JOINT CITY PLAN COMMISSION & HISTORIC PRESERVATION / DESIGN REVIEW COMMISSION

2. Presentation by Somerville Architects on the proposed City Hall Campus.
3. A request from the City of Stevens Point for a design review to construct a principal structure, parking lot and associated site improvements on an unaddressed parcel bounded by Water Street and Ellis Street (Parcel ID 281240832202055), consistent with Ch. 22.05(2).
4. A request from the City of Stevens Point for a site plan review to construct a principal structure, parking lot and associated site improvements on an unaddressed parcel bounded by Water Street and Ellis Street (Parcel ID 281240832202055).

Design Review & Site Plan Review City Hall – Bounded by Ellis & Water Street February 2, 2026

Site & Landscaping Plan – No Enclosed Parking Area

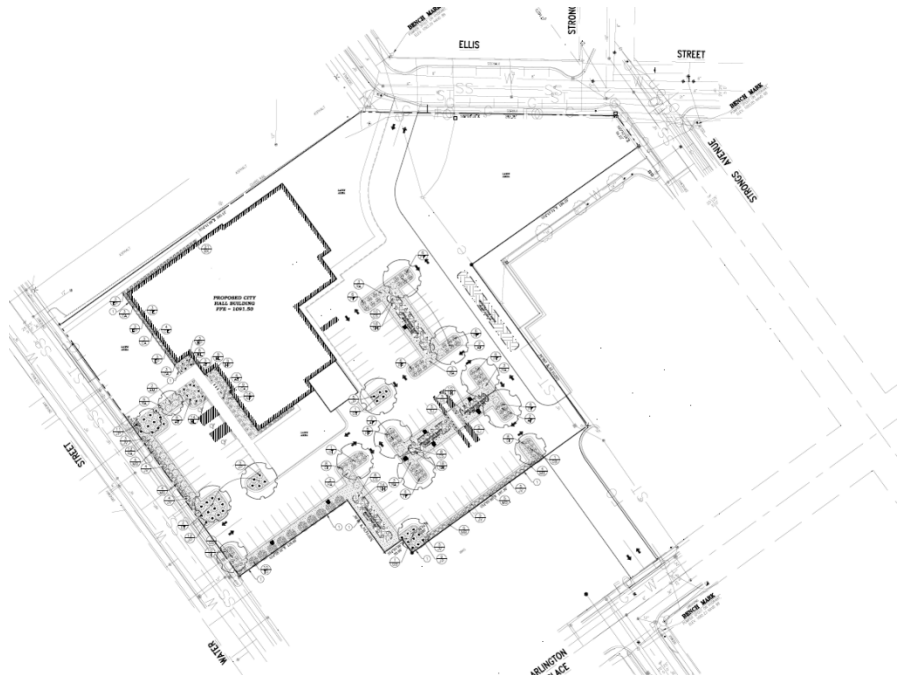
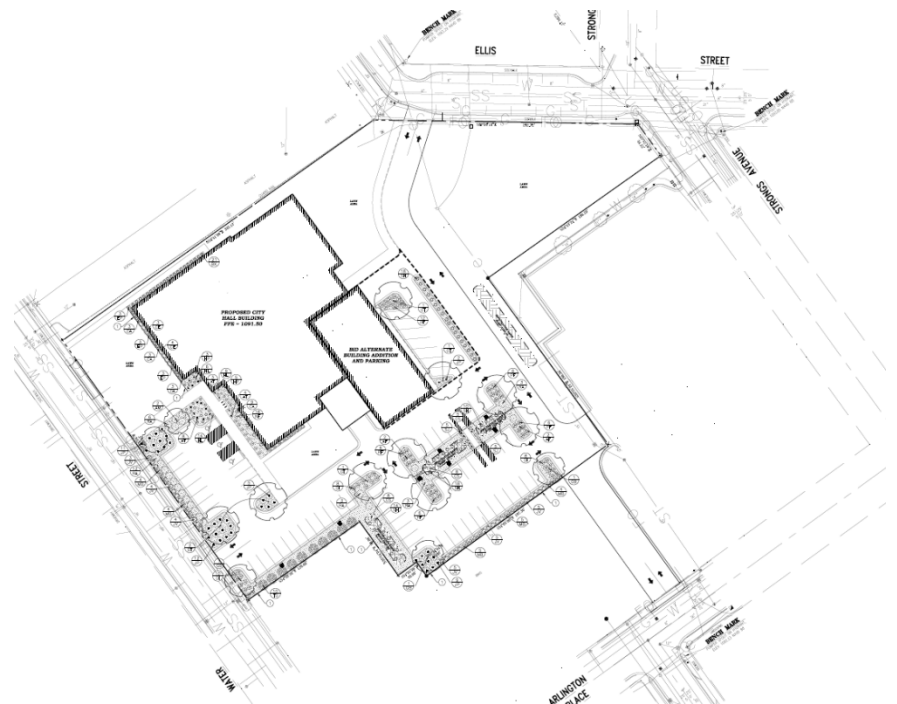
Analysis: A building setback of 66 feet is proposed off of Water Street. Adjacent buildings range significantly in terms of the amount of building setback provided from a street. The Berkshire building provides roughly four feet of street setback off of Water Street, 18 feet provided for the Beth Israel Synagogue, and 13 feet for the Portage County Annex building. A greater street setback is being requested for City Hall due to the amount of visitor traffic coming in and out of the site, and ensuring that parking accommodations in close proximity can be provided. Additionally, the building is requested to be set back farther to preserve an open space area adjacent to Water Street.

Analysis: Ten feet of side yard setback is provided from the northwest lot line.

Analysis: Parking is provided in the front, side and rear elevations of the building.

Findings: As part of this request, the City is requesting a deviation from this standard to allow for parking closer to the street lot line.

Analysis: The submitted landscaping plan proposes a range of 40’ tall trees, 3-4’ tall shrubs, ornamental grasses

Analysis: Most shrub species are proposed to be 3-4' in height, with the exception of Techny Arborvitae that would stand 10-15' tall at maturity. These shrubs would be located near the southeast corner of the subject area.

Findings: As part of this request, an exception is being sought to allow for a taller shrub to provide separation between the City Hall building and the Beth Israel Synagogue.

Analysis: The parking lot is broken up by terminal landscaped islands as required in the City's Zoning Code. Perimeter landscaping is also proposed.

WEST ELEVATION - NO INDOOR PARKING OPTION
SCALE: 1/8" = 1'-0"

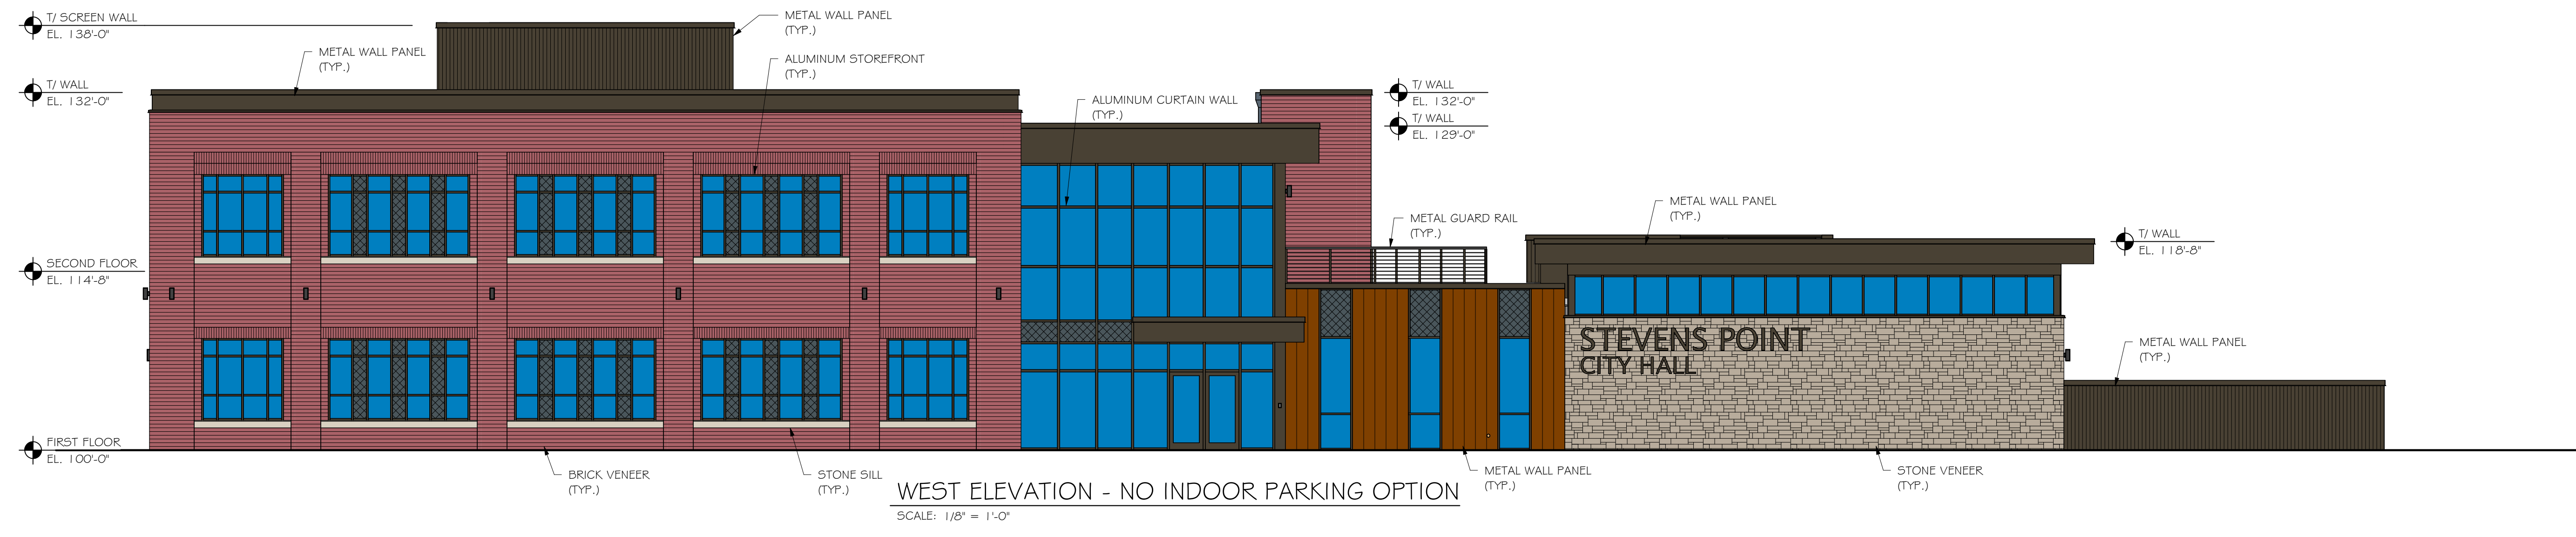
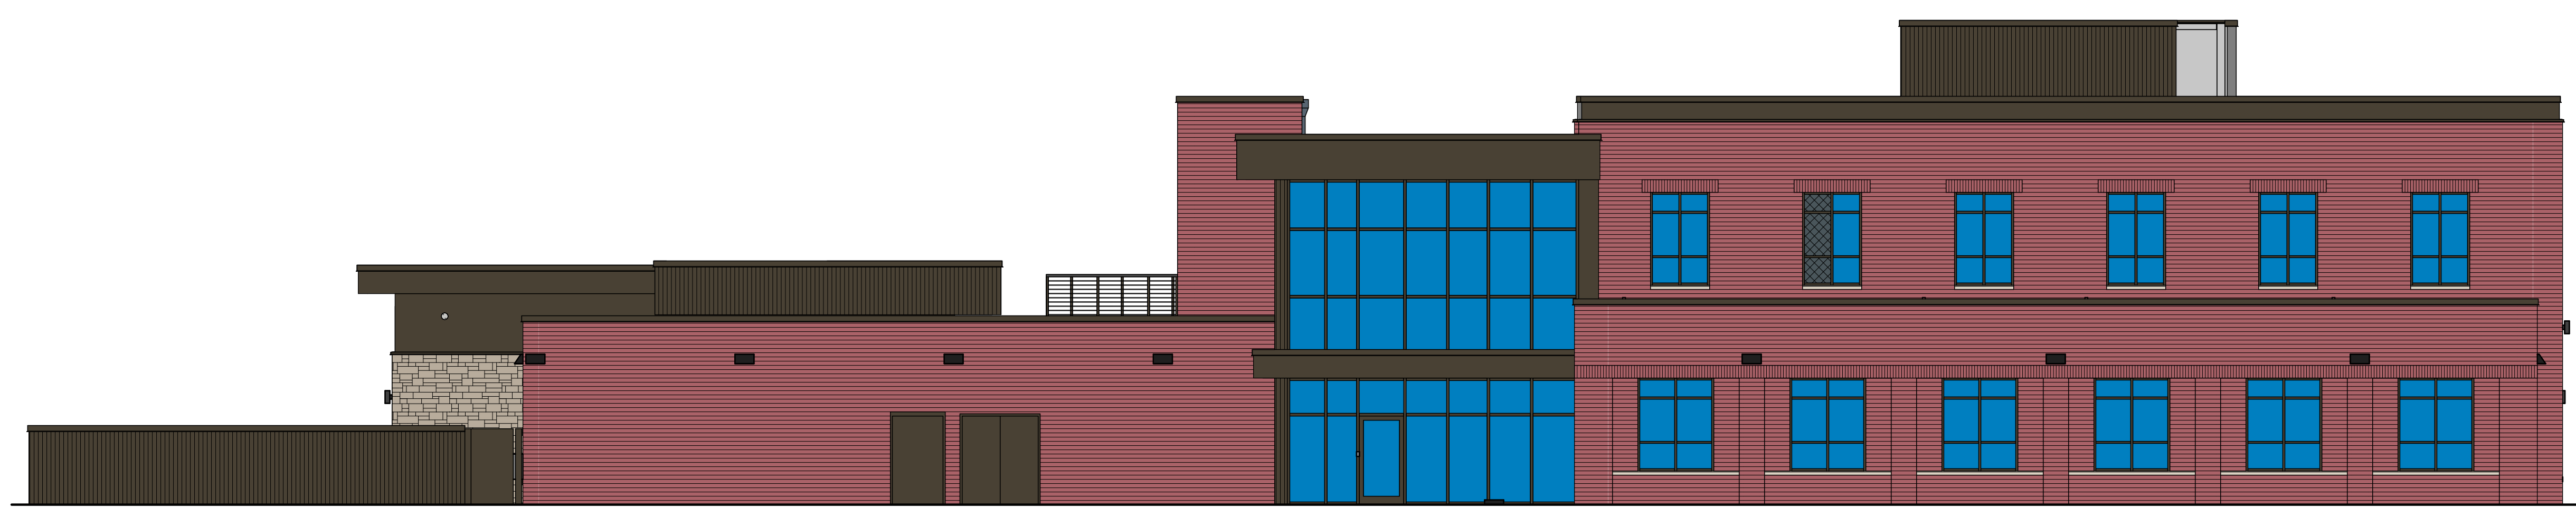
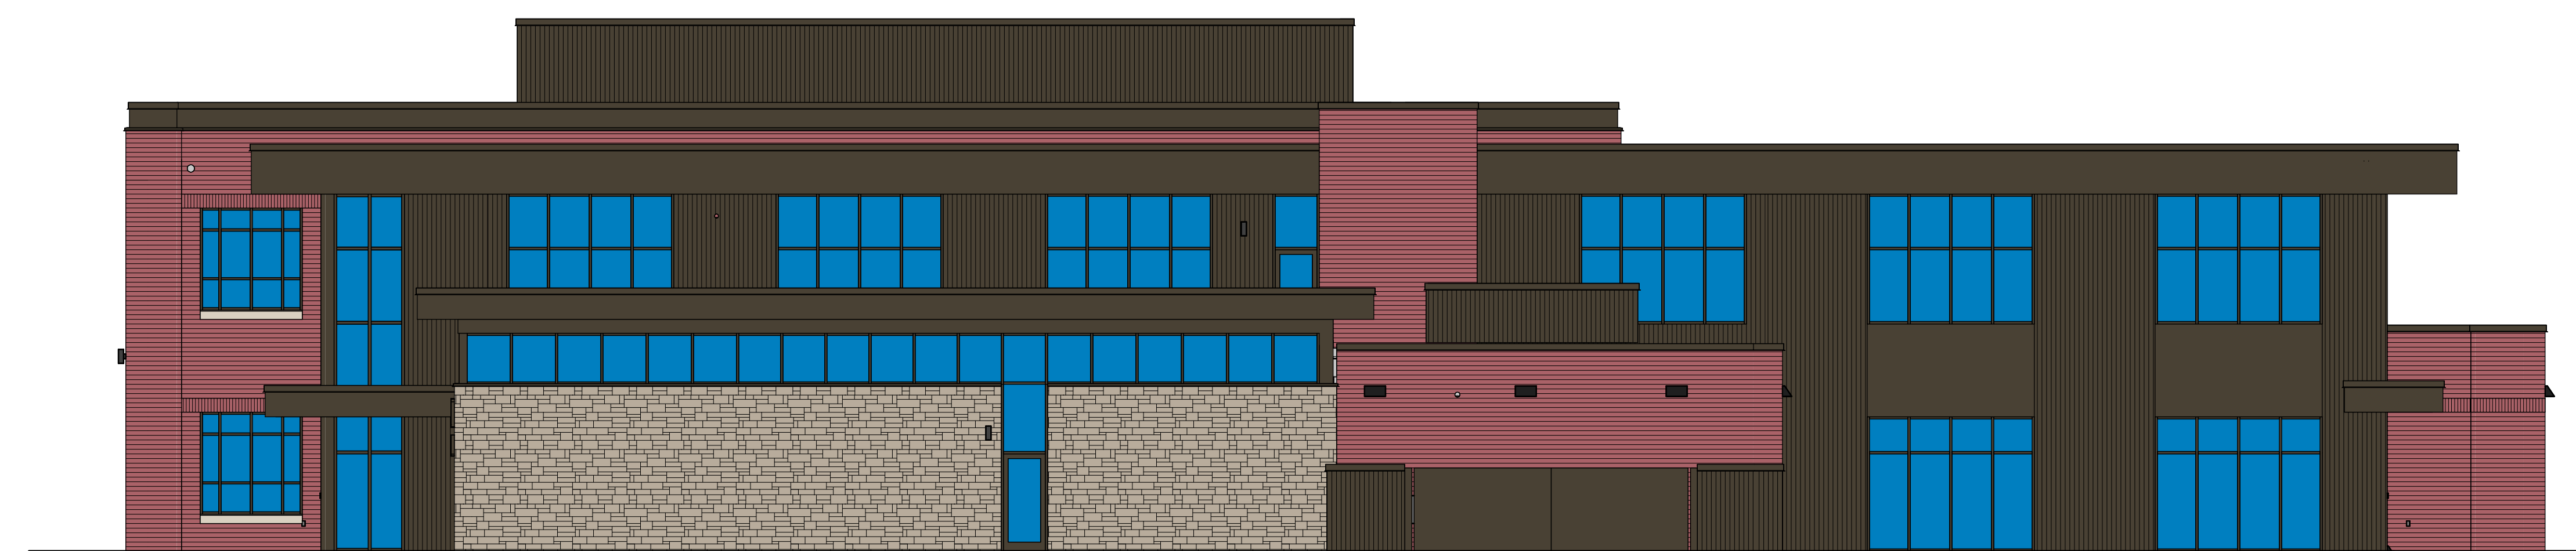
Analysis: The proposed building would stand two stories in height at a peak height of 38 feet. Adjacent buildings range from being single-story (e.g., Children’s Wisconsin & the Beth Israel Synagogue) to five stories in height (e.g., Berkshire).

Findings: The proposed two-story building would a comparable height to neighboring buildings and serve as a gradual increase in peak building height from the south to the Downtown area.

Analysis: The proposed building would stand 38 feet in height. A maximum building width of 197 feet would exist if an enclosed parking area were not added onto the building. If the enclosed parking area is added onto the building, maximum building width would be 218 feet.

Findings: The building has a proposed square look to it that is similar with other multi-story buildings located in the near vicinity (e.g., Berkshire, Courthouse, etc.).

Analysis: The main entrance is proposed to be off of Water Street, with secondary employee only access along the north elevation. Primary architectural details are located along the front elevation – ranging with the use of brick veneer, metal wall panel and stone veneer.

Analysis: The proposed building aims to be compatible with the Weber Tackle Building that was historically located on the subject area. As shown within the elevation plans, the proposed building complements key features of the Weber Tackle Building – the use of brick veneer and a fenestration pattern that has a similar ratio of solids and voids – to present an industrial feel for a building that will house an institutional use.

Analysis: Brick veneer is the predominant façade material used on the proposed building, with other materials used consisting of metal and stone.

Analysis: Aluminum is the proposed material for the window muntins. Vinyl siding is not proposed.

Findings: While aluminum is proposed for the windows, its feature is small in scale compared to the other façade materials that would be used.

Analysis: A parapet wall and metal guard rail are proposed to provide greater variation in true building height.
